**COASTSIDE COUNTY WATER DISTRICT
HALF MOON BAY, CALIFORNIA**

ADDENDUM NO. 4

**Contract Documents for
Denniston Culvert Replacement and Paving Project**

SHEET NUMBER
3
3 OF 6

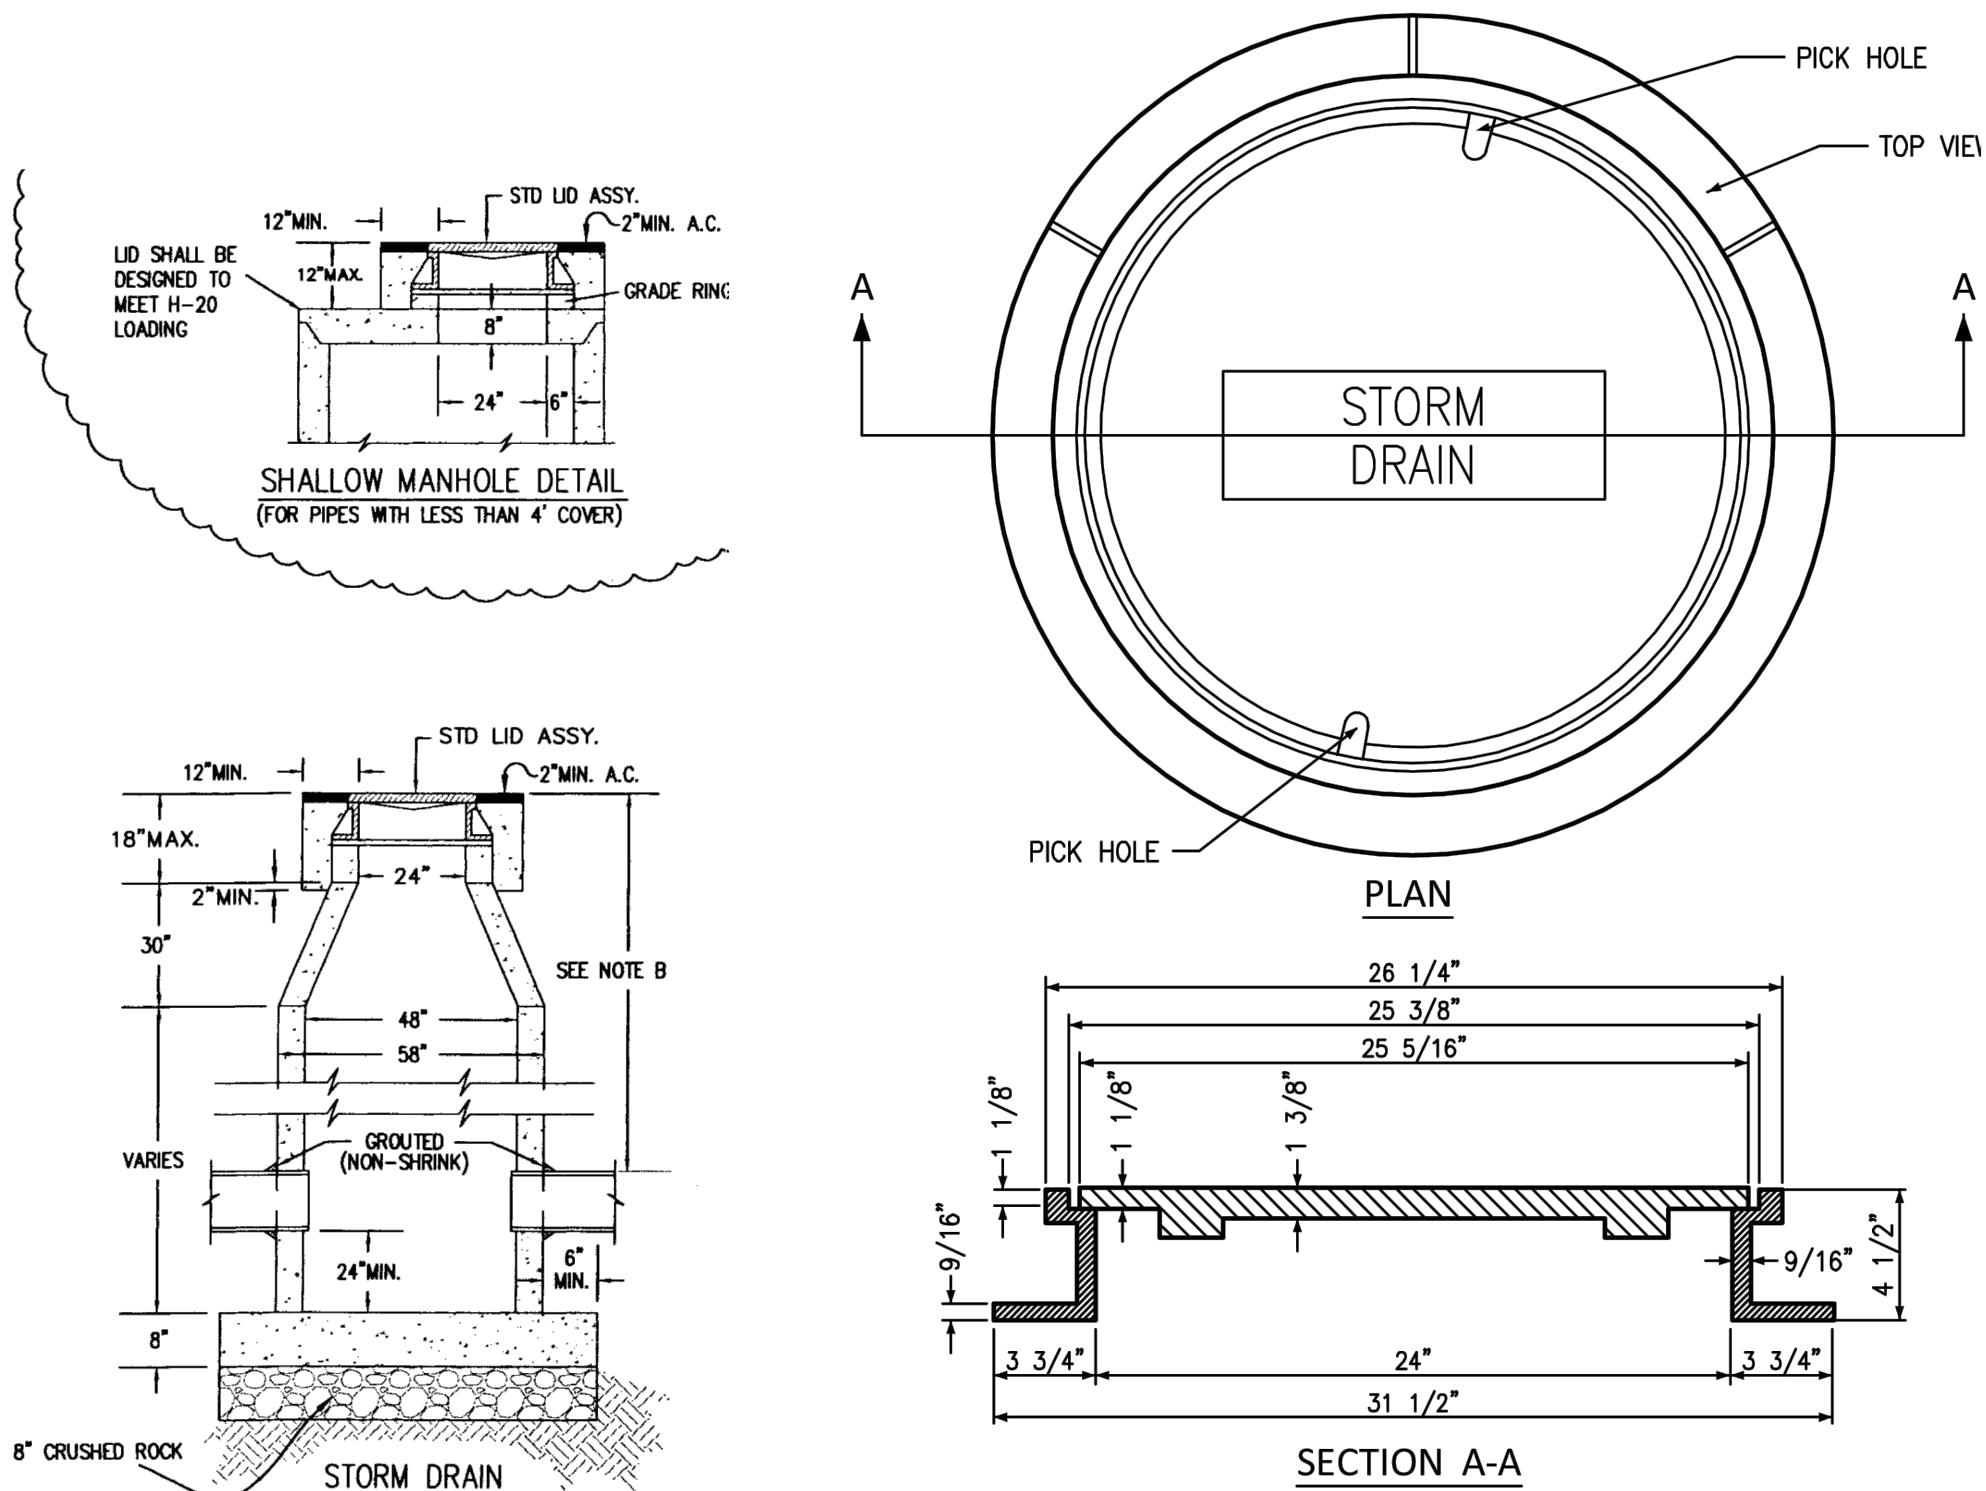
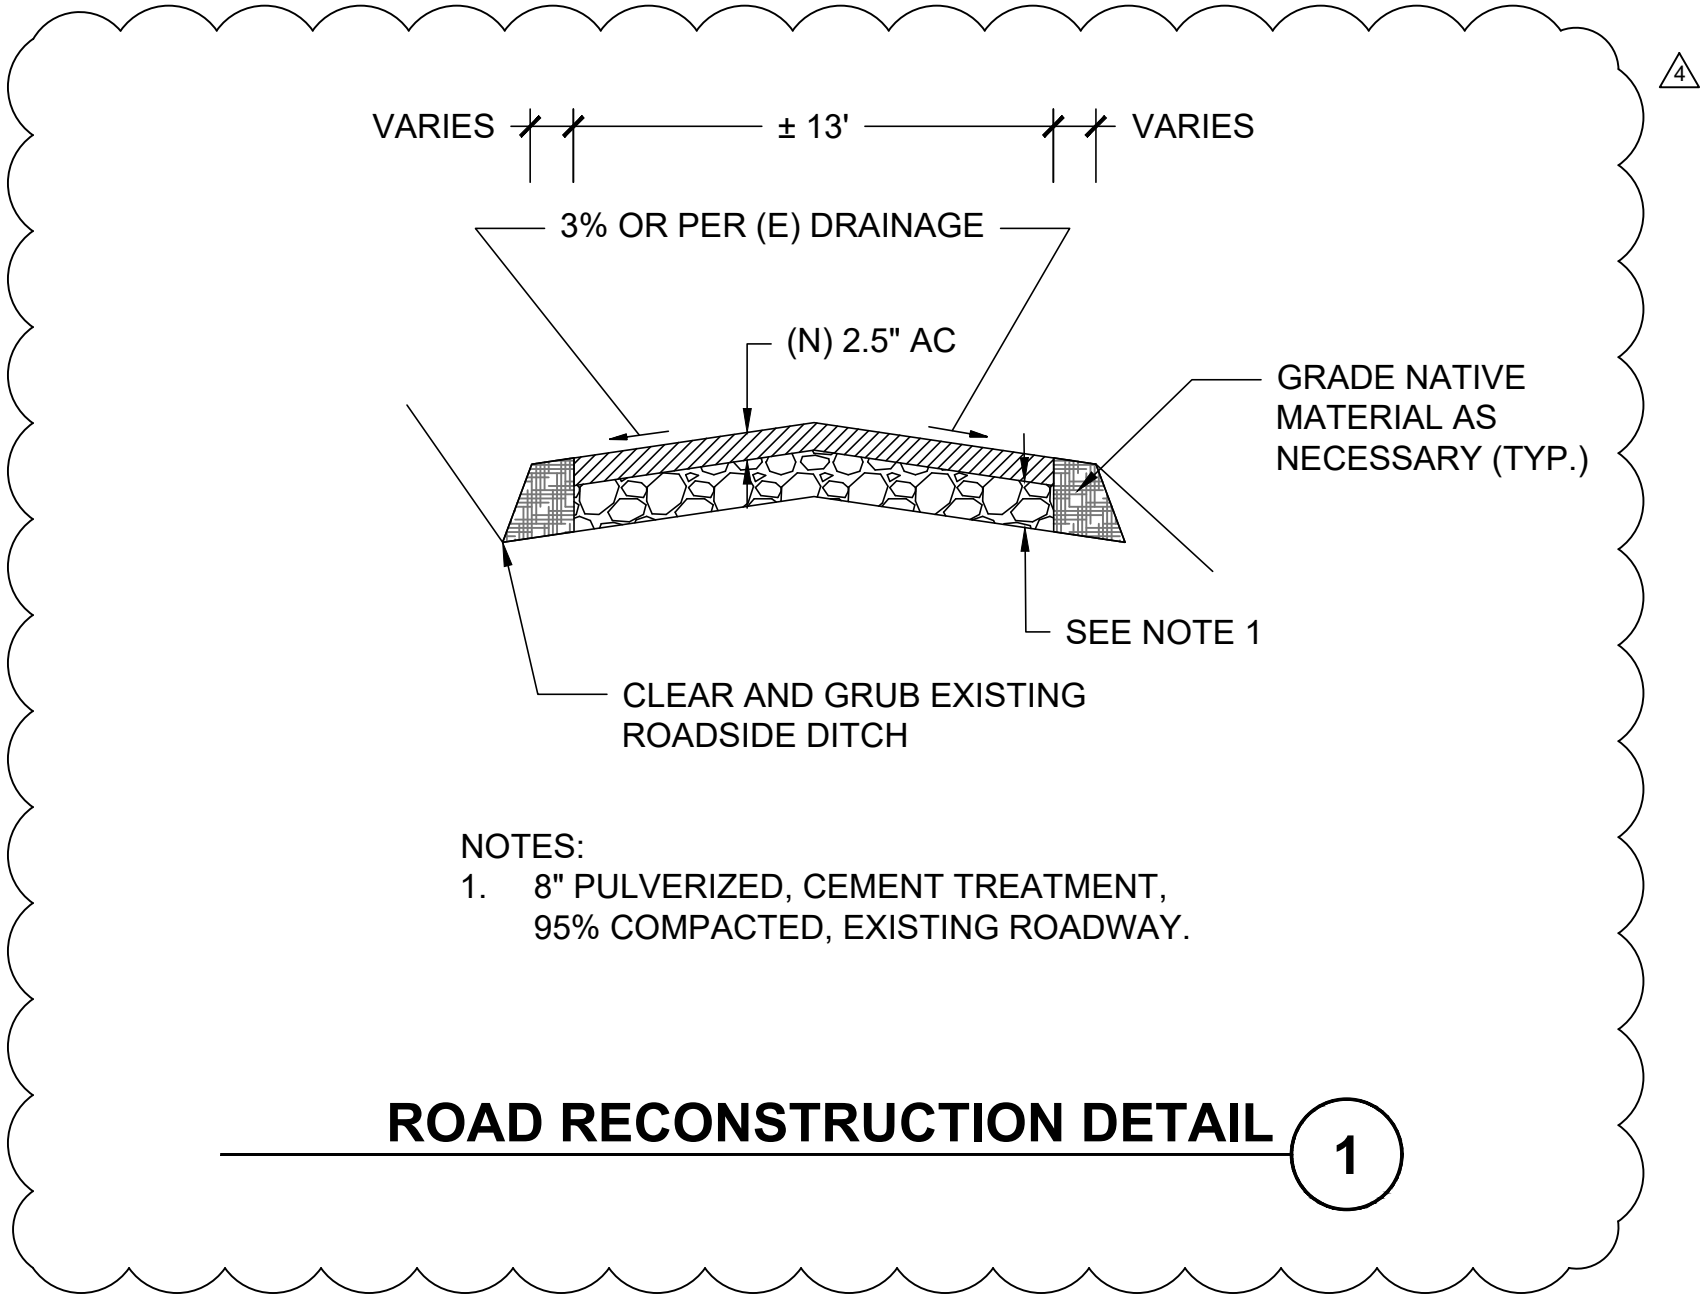
Item No.	Bid Document Sheet No. or Section No.	Description of Change or Clarification
4.003	Replace Sheet 3 with attached	Area of improvements at water treatment plant has been updated. Grading has been adjusted to include this new area.
4.004	Replace Sheet 4 with attached	Detail 1 has been updated. Detail 3 has been updated to show that drain inlet top shall be an "open grate", rather than "solid or open grate".
4.005	Replace Sheet 5 with attached	District Standard Detail CC-23 has been included.

- 9 INSTALL 36" WIDE CONCRETE VALLEY GUTTER PER DETAIL 
- 10 INSTALL AC DIKE AROUND POND, TO THE FULL EXTENT OF THE NEW ASPHALT. SEE DETAIL 
- 11 EXTENTS OF PAVING SHOWN ON THE PLAN, AROUND THE WATER TREATMENT FACILITIES IS APPROXIMATE. EXACT LOCATION TO BE VERIFIED IN FIELD BY DISTRICT. CONTRACTOR SHALL VERIFY EXISTING BASE ROCK DEPTH PRIOR TO CONSTRUCTION AND INFORM DISTRICT AND ENGINEER IF THE EXISTING BASE IS LESS THAN 6-INCHES. EXISTING GRAVEL AREA SHALL BE GRADED AND COMPACTED TO 95% RELATIVE COMPACTION. A 2.5-INCH ASPHALT SECTION SHALL BE PLACED OVER THE GRADED AND COMPACTED SECTION. AREA SHALL BE GRADED TO MATCH EXISTING DRAINAGE PATTERNS AS SHOWN. SURFACE CROSS SLOPES SHALL BE A MINIMUM OF 2% AND A MAXIMUM OF 10%, AS NEEDED.
